Access Compliance Report

Public Rights-of-Way

(Curb Ramps)

Intersection ID: 28106	Main Street: TOLLIVER_DR	Cross Street: GUNNISON_LN	Location: SE
ADA ID: BE59F6FB3C5C	Ramp Type: PerpDiag	Initial Pass/Fail: Fail	Overall Compliance: No
Severity Score: 37.5			
Codes/Mitigation Info/Possible Solution		Field Measurements/Component Compliance

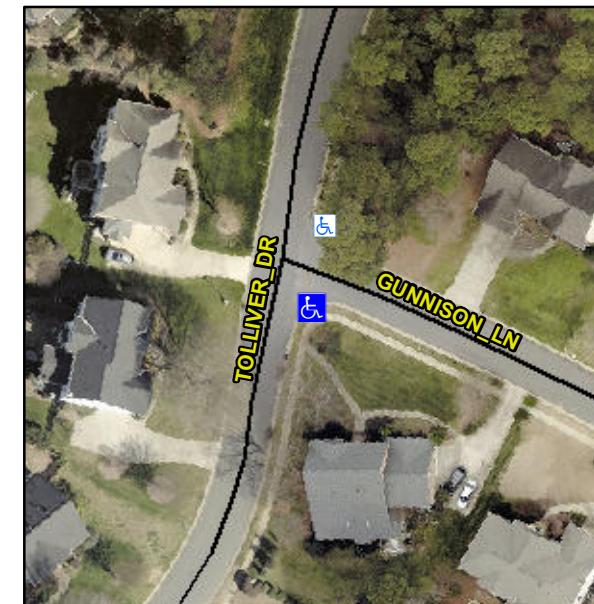
Not Found, R304.2.2, R304.5.3

Compliance	Description	Data	Compliance	Description	Data
N/A	Ramp Length (in)	100.5	No	Ramp Slope (%)	9.2
Yes	Ramp Width (in)	48.0	No	Ramp XSlope (%)	8.9
N/A	Flare Type LT	N/A	N/A	Flare Type RT	N/A
N/A	Flare Slope LT (%)	N/A	N/A	Flare Slope RT (%)	N/A
N/A	Flare Traversable LT?	N/A	N/A	Flare Traversable RT?	N/A
N/A	Landing Length (in)	N/A	N/A	DWS Provided?	N/A
N/A	Landing Width (in)	N/A	N/A	DWS Contrast?	N/A
N/A	Landing Slope (%)	N/A	N/A	DWS Length (in)	N/A
N/A	Landing X Slope (%)	N/A	N/A	DWS Full Width?	N/A
N/A	Landing Curb? (Y/N)	N/A	N/A	DWS Offset (in)	N/A
N/A	Shared Landing?	N/A			
N/A	Gutter Ponding?	N/A	N/A	Gutter Slope (%)	N/A
N/A	Gutter Lip Ht (in)	N/A	N/A	Gutter X Slope (%)	N/A
N/A	Painted X Walk1?	No	N/A	Painted X Walk2?	No
	X Walk 1 Direction	To NE		X Walk 2 Direction	To W
N/A	X Walk 1 Width (in)	N/A	N/A	X Walk 2 Width (in)	N/A
	X Walk 1 Slope (%)	1.3		X Walk 2 Slope (%)	0.5
	X Walk 1 X Slope (%)	3.0		X Walk 2 X Slope (%)	2.0

N/A	Ramp inside XWalk1?	N/A	N/A	Ramp inside XWalk2?	N/A
	Road Slope (%)	5.2	N/A	Clear Space?	N/A
	Road X Slope (%)	0.1	N/A	Clear Space to XWalk (in)	N/A
N/A	Any Obstructions?	N/A	N/A	Storm Grate/Utility Hazard?	N/A
	Obstruction Type			Storm Grate/Utility Type	
		N/A			N/A
		Yes		Surface Condition? (G/P)	Good

Remove & Replace Curb Ramp With Two New Directional Ramps or Equivalent.
